HOPE CREEK GENERATING STATION  
DOCKET NO. 50-354  
FSAR COMMITMENT STATUS THROUGH AUGUST 1984

ATTACHMENT I  
HOPE CREEK GENERATING STATION  
FSAR COMMITMENT STATUS THROUGH AUGUST 1984

QUESTION 220.21 (SECTION 3.7.2)

FIGURE 210.21-25  
 RESPONSE SPECTRA COMPARISON,  
 AUXILIARY BUILDING AT ELEV. 54'-0",  
 E-W, SSE, 2% DAMPING

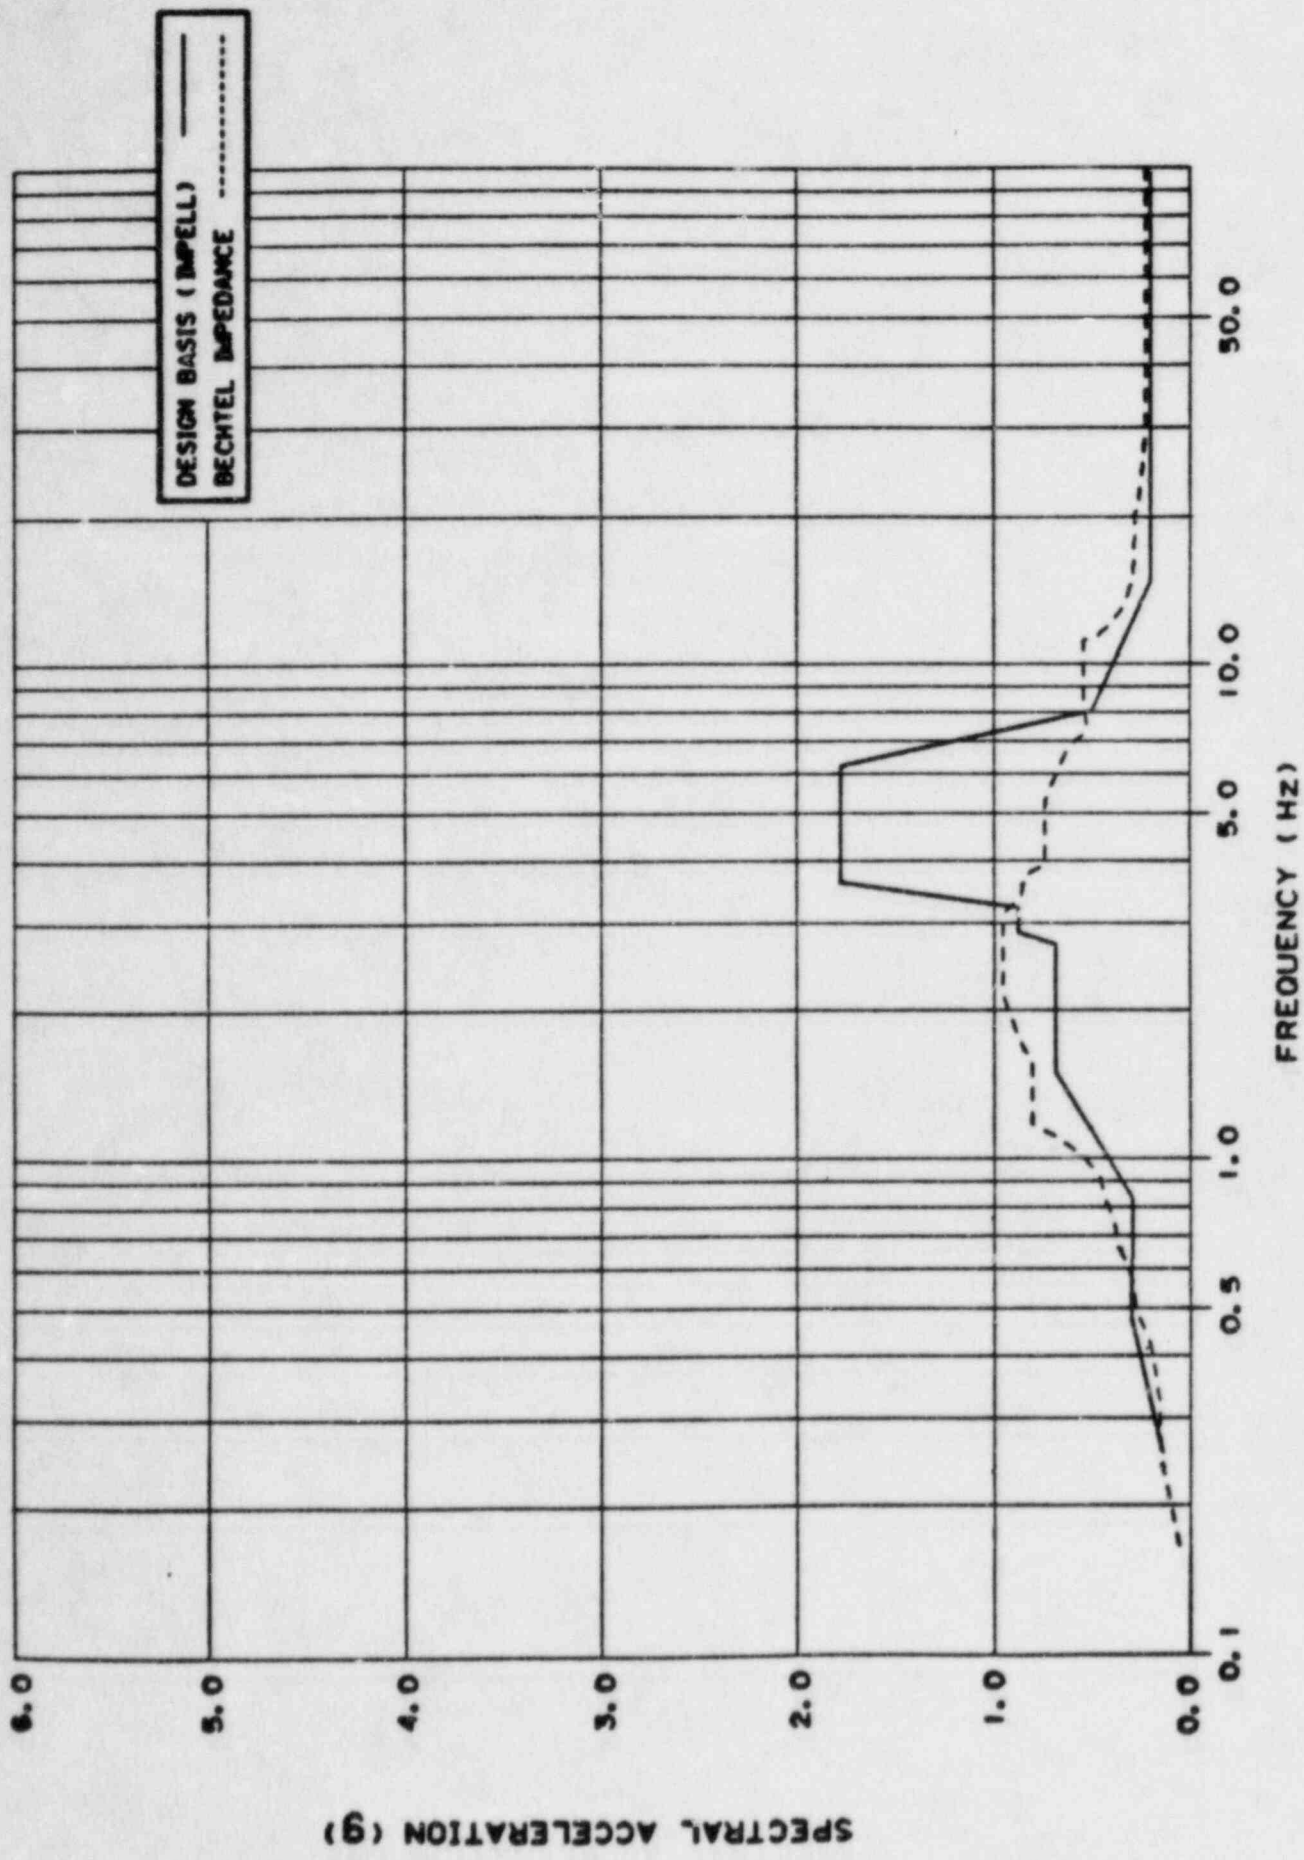
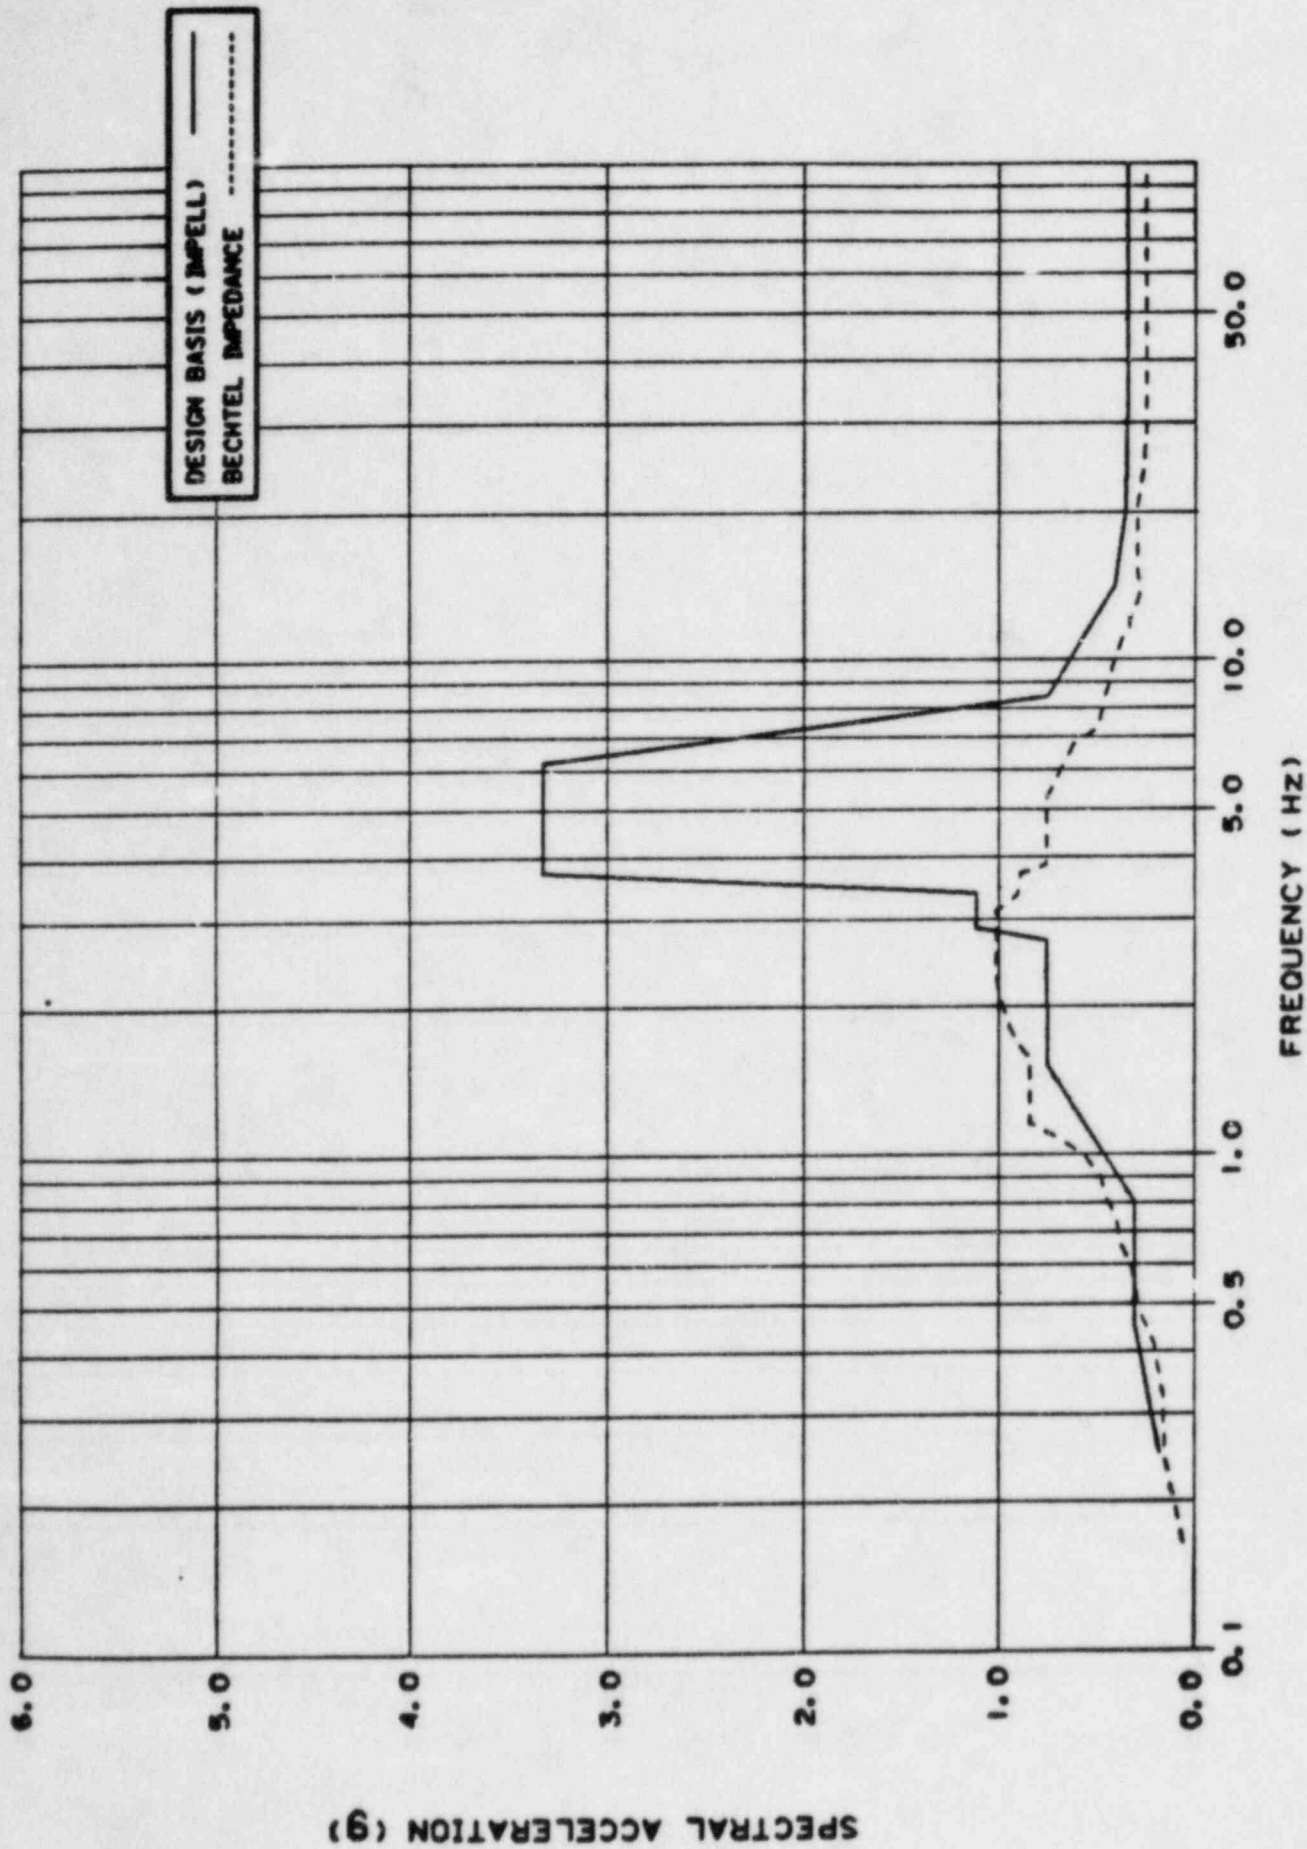
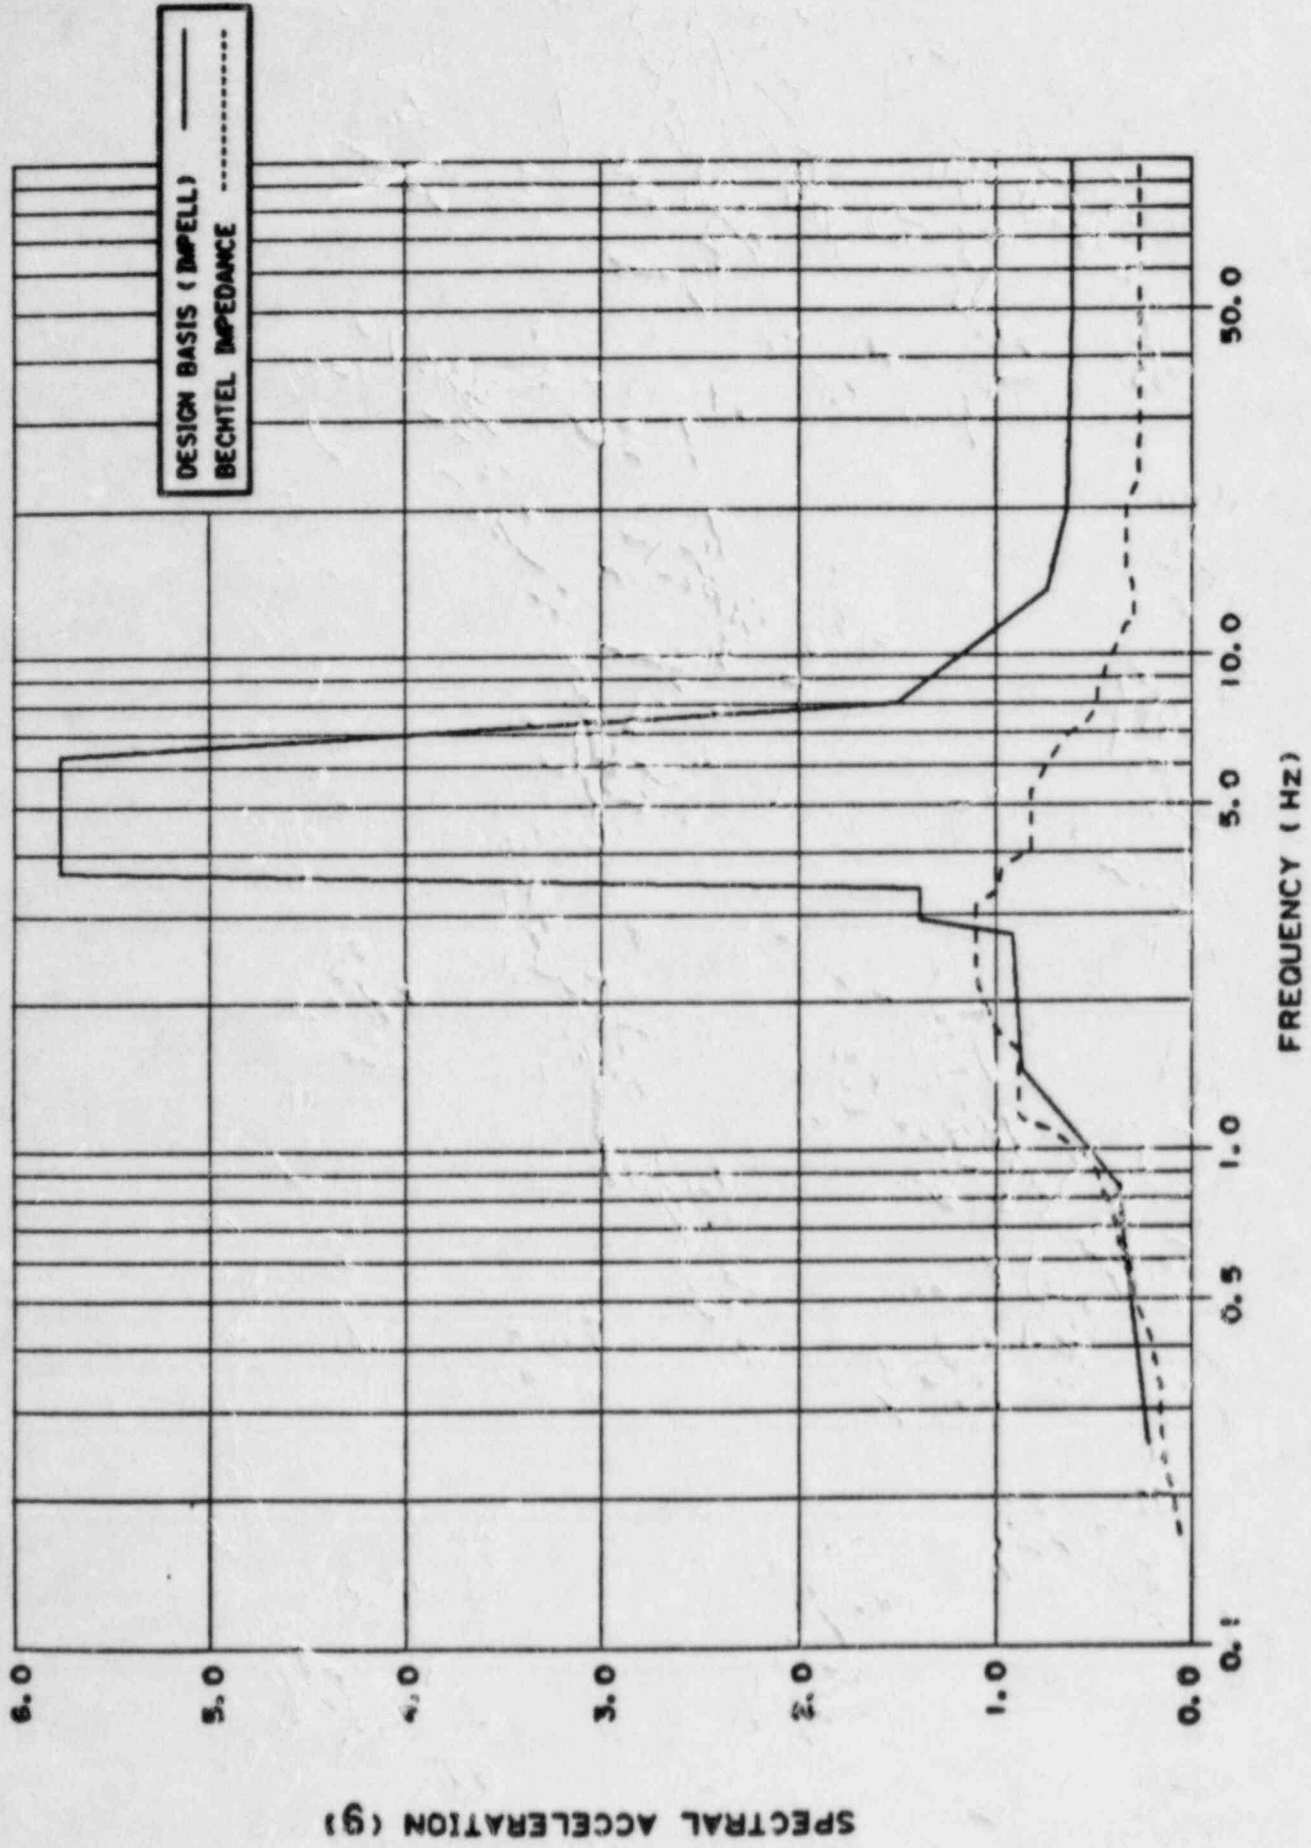
The Hope Creek soil-structure interaction analysis is performed by applying a specified earthquake input motion at the base of the finite-element model. The base level input motion is generated through a deconvolution analysis. The applicable SRP criteria for soil-structure interaction analysis require that both the half-space and finite-element approaches should be considered. (For details refer to SRP 3.7.2-11.4). Public Service should perform necessary analyses to demonstrate conformance to the criteria.

Figures 220.21-1 through 220.21-54 show a comparison of the 2 percent damping response spectra obtained from the design basis finite element and the impedance analyses for the reactor building, auxiliary building and the service water intake structure (SWIS).

¶ For the reactor and auxiliary buildings, the peak spectral accelerations obtained from the impedance analysis are generally lower than those obtained from the design basis analysis. However, the impedance analysis response spectra are not completely enveloped by those obtained from the design basis analysis, especially in the frequency range from 1.0 to 3.5 Hz. Also, there are some local exceedances in the higher frequency range, as shown in Figures 220.21-1 through 220.21-36. ¶ For the SWIS (Figures 220.21-37 through 220.21-54), the impedance analysis response spectra are generally enveloped by those obtained from the design basis analysis at elevation 114.0 feet. For other elevations, the impedance analysis spectral accelerations exceed the design basis spectral accelerations in some frequency ranges. These ranges vary approximately between 1.5 and 10.0 Hz.

forces and moments obtained from the impedance analysis exceeded the design basis values at various locations within these buildings. The auxiliary building seismic shear forces and moments obtained from the impedance analysis are less than the design basis shears and moments.

Since the impedance analysis results are not completely enveloped by the design basis finite element analysis results, sampling studies are conducted to confirm the adequacy of the plant design. These sampling studies include an evaluation of the following items:

In all cases, the items reviewed during these sampling studies can accommodate the loads resulting from the impedance analysis. Therefore, the impedance analysis results have no impact on the plant design.
